RESPONSE TO COMMENTS

FOR THE TALBERT LAKE DIVERSION PROJECT INITIAL STUDY/MITIGATED NEGATIVE DECLARATION

**RESPONSE TO COMMENTS FOR INITIAL STUDY/
MITIGATED NEGATIVE DECLARATION NO. 08-003 for the
TALBERT LAKE DIVERSION PROJECT**

Figure 1
Orange County Sanitation District
Dry Weather Urban Runoff Diversion Monthly Averages, gpd

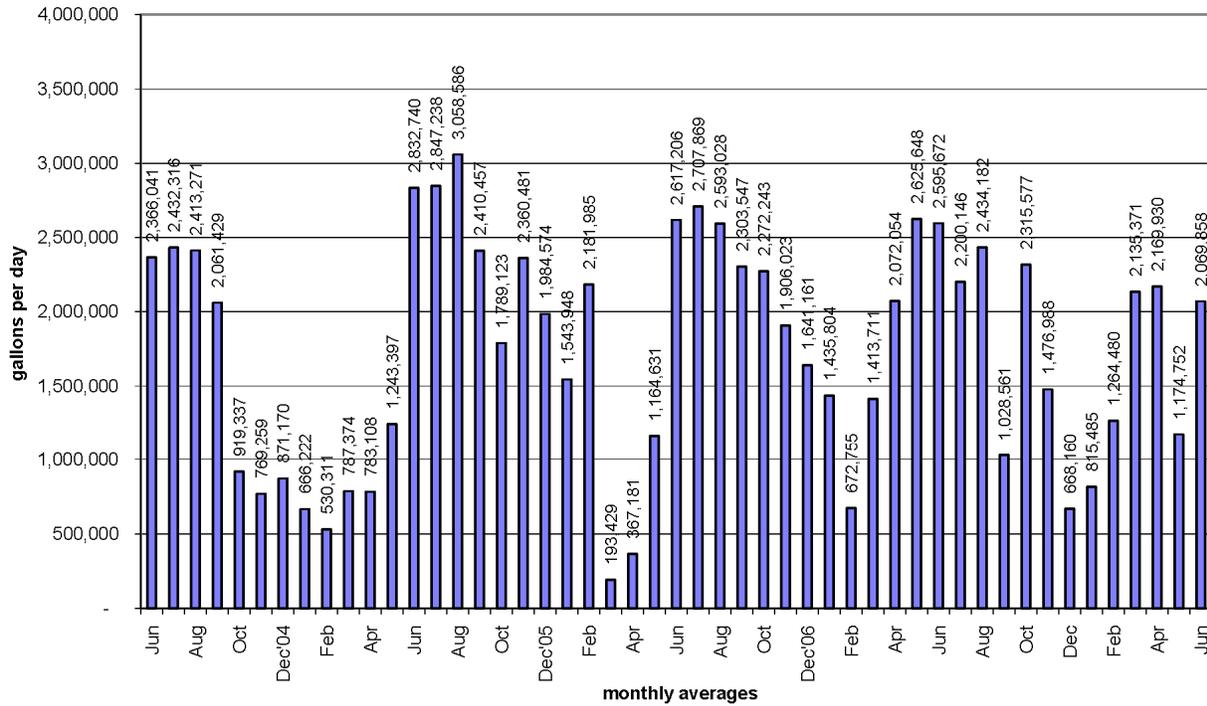
- b.) The IS/MND (p. 61) lists water quality monitoring data for the East Garden Grove Wintersburg Channel (EGGWC) showing total dissolved solids (TDS) concentrations ranging from 1,200 to 8,700 mg/L. These concentrations substantially exceed the Basin Plan TDS Objective of 583 mg/L and could degrade groundwater quality if these are representative of the water proposed to be diverted and infiltrated. Since the water sample locations appear to be downstream of the 2

The proposed natural treatment system would not have any effect on TDS concentrations of incoming diverted flows. Based on these recent monitoring data, the average TDS concentration in the channel at the diversion site is 423 mg/L, which is lower than the objectives stated in the Basin Plan. Accordingly, TDS should not be a concern.

Nitrate concentration removal efficiencies were assessed for the proposed project by using average inflowing EGGWC concentrations from varying diversion flow rates (as illustrated in Table 1 below) and applying them to 9.4 acres of treatment wetlands. Average annual outflow concentrations (Table 1) indicate that the Talbert Lake Wetland Treatment System could be operated continuously at about 1.25 million gallons per day (mgd) without exceeding the Basin Plan's limitations of 3.4 mg/L for NO₃.
